CITY PLAN COMMISSION STAFF REPORT

Chaves (Formerly SeaBiscuit)

- .1 - CD-CPC-2020-00065 – Rezoning.
- .2 - CD-CPC-2020-00066 – Signage Plan.
- .3 - CD-CPC-2020-00067 – Development Plan.

Project: Chaves Development

PEACHY PARKING OVERSIZED MONUMENT SIGN

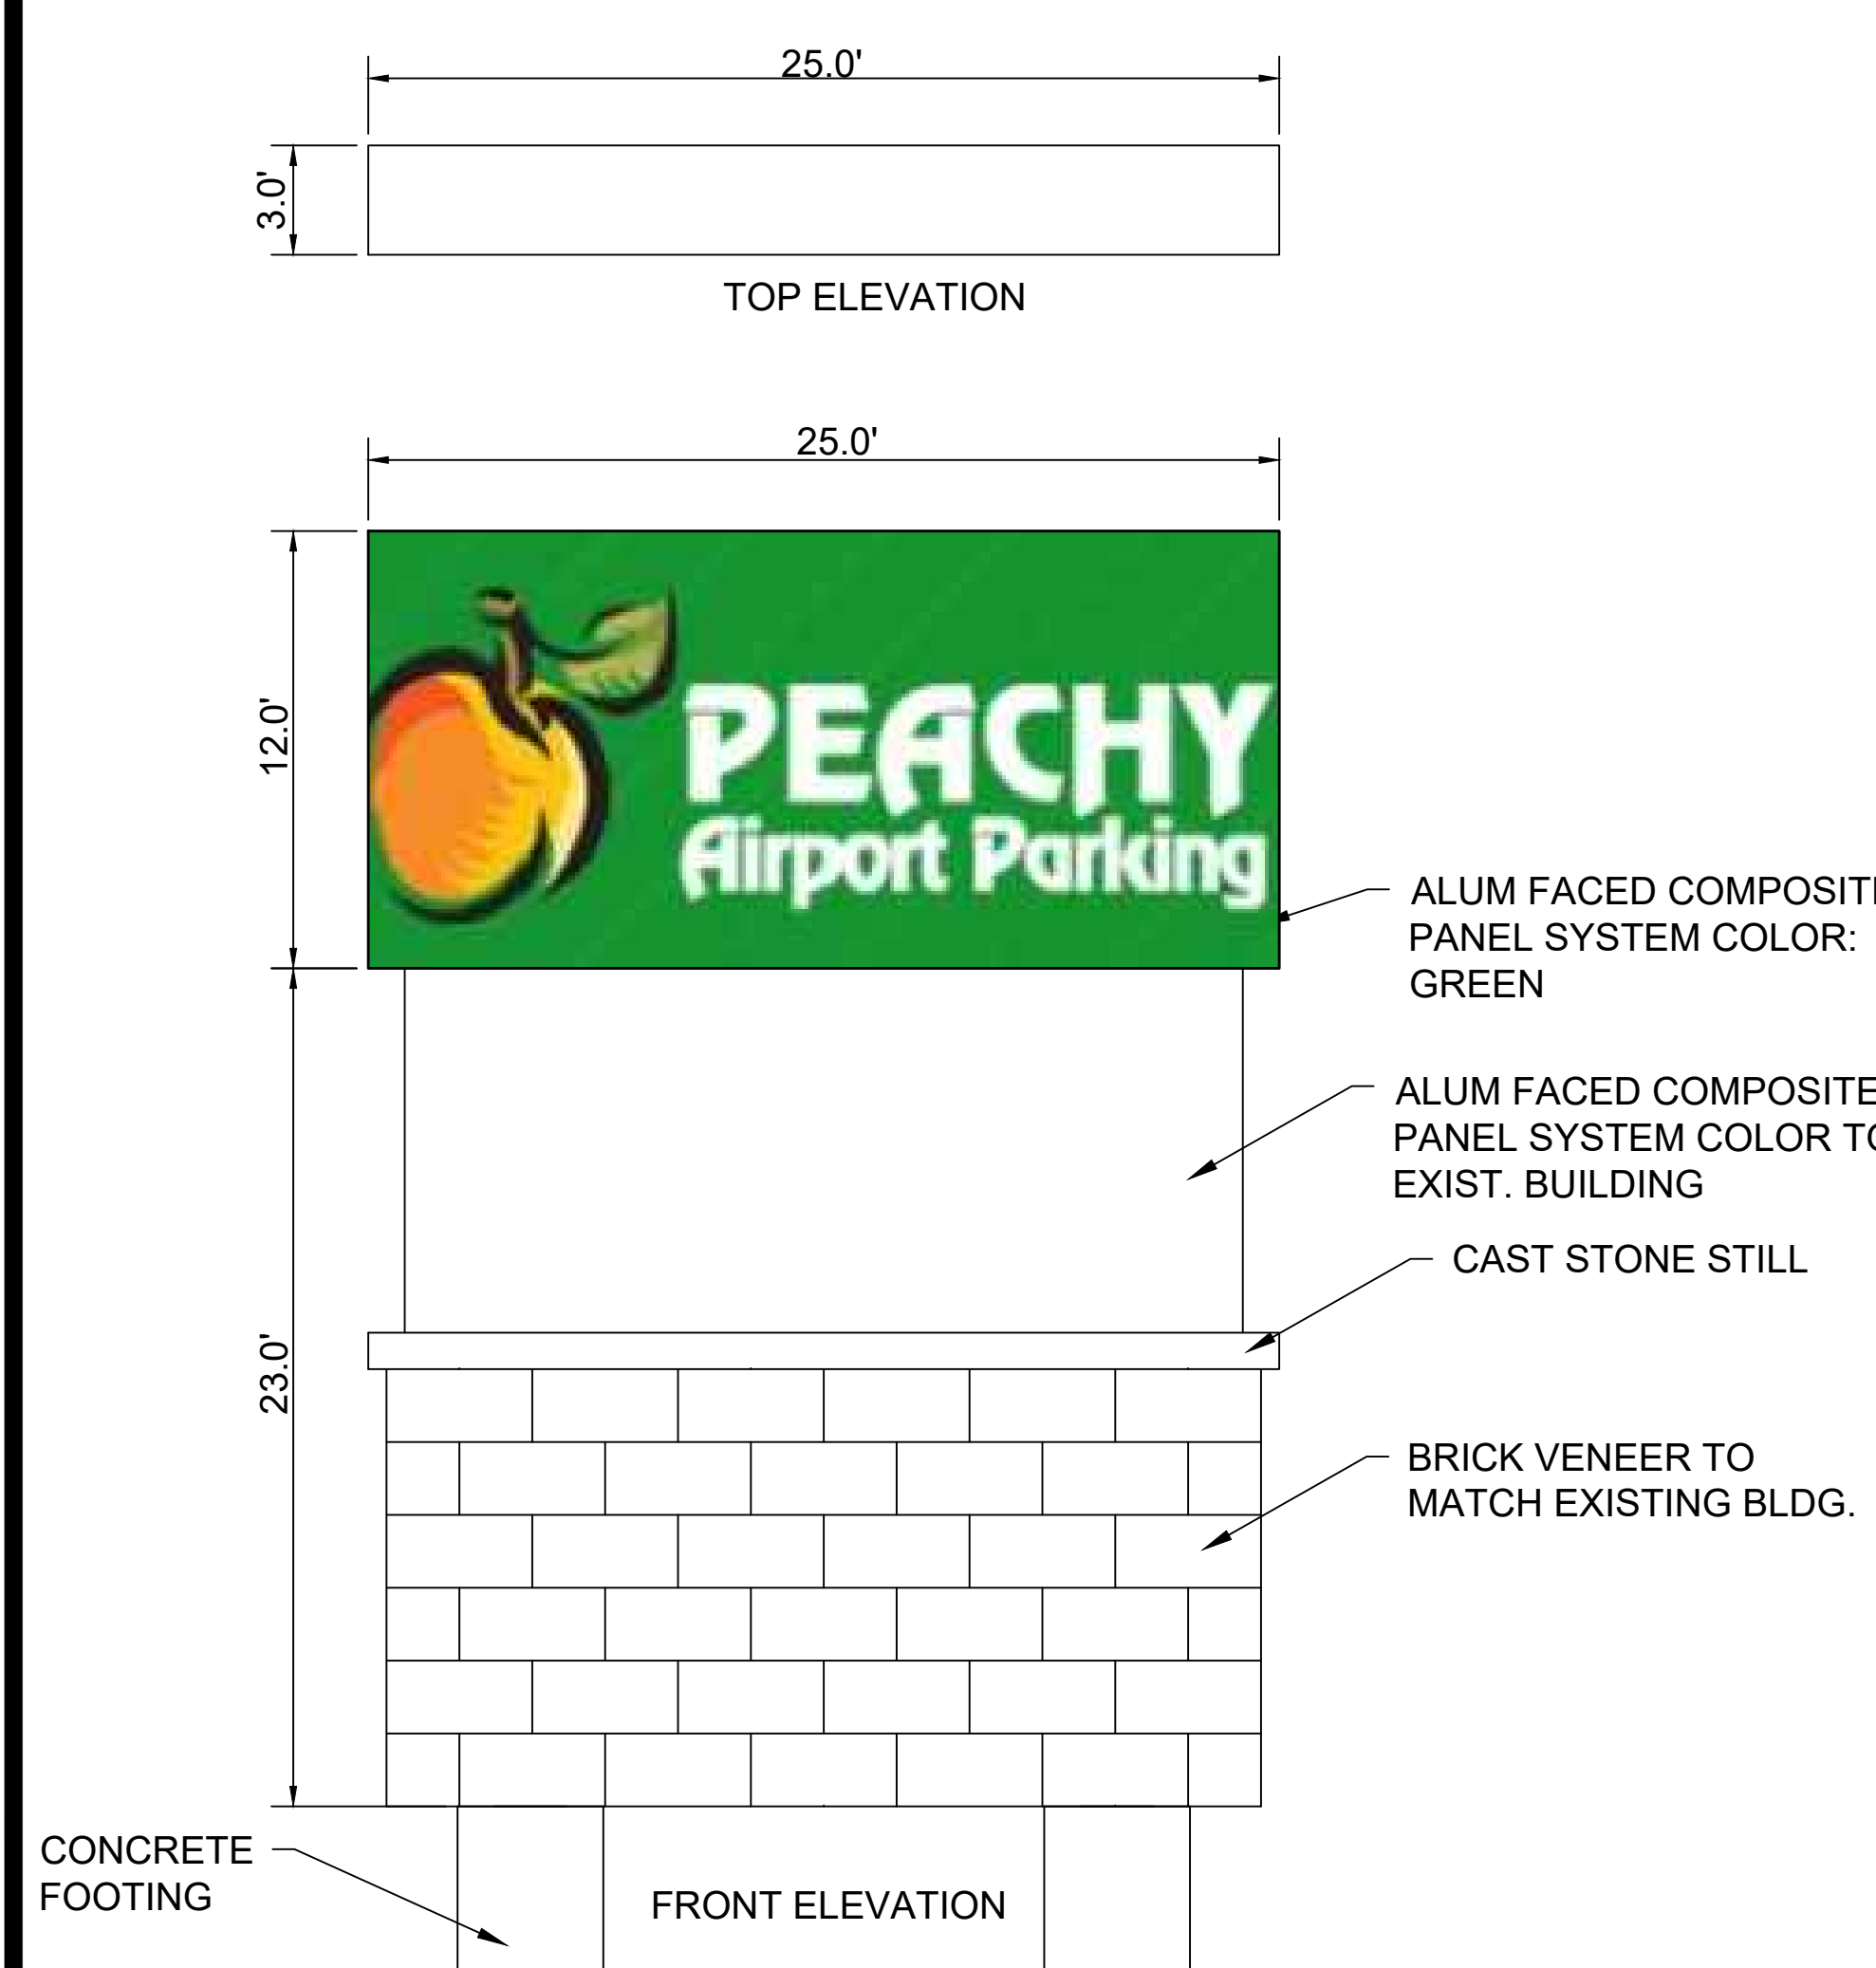
Case No. CD-CPC-2020-00066 is a request for approval of a Council Approved Signage Plan in District B3-3 (Community Business - 3) pursuant to Section 88-445-11 to allow for three oversized Monument signs as part of the Chaves Development. The proposed signs are 35 feet in height and 300 square feet in size. The signs are proposed to be constructed of aluminum faced composite materials on a brick base with and aluminum clad composite middle to match adjacent buildings. The main entry sign will be a single user sign and the other two signs will have up to 6 tenant panels. The signs must be setback 20 feet from the property line. Staff recommends some revisions to show the actual sign (25' wide) on the site plan.

The applicant is proposing to install several oversized monument signs as a companion case. Staff recommends that the plan be revised to properly show locations of all proposed signage for this development. The revised plan shall be approved prior to ordinance request.

1. Provide an approximate timeline of when each oversized monument sign will be constructed with the phases of the related Development Plan. (5/12/2022)
2. Staff recommends that the southwest sign should incorporate multi-tenant signage as well. It is the closest to the interchange and major intersections as well as the western main drive to the development. (5/12/2022)
3. Assuming the paid parking lot is constructed first, what will the anticipated colors be of those that say to match the existing building? The existing office tower or proposed commercial buildings? (5/12/2022)

4. If the associated Development Plan (CD-CPC-2020-00067) should expire, this associated Council Approved Signage Plan shall be deemed expired as well. (4/27/2020)
5. The proposed oversized monument signs shall not be constructed into the associated lot or tract of land where the sign will be placed is platted. (4/27/2020)
6. No oversized monument sign permit shall be issued until permits for Phase 1 of the development are issued to constructed either necessary infrastructure or building permits. (4/27/2020)
7. Vacate the existing right-of-way for NW 122nd Ct in association with any future Final Plats. (4/29/2020)
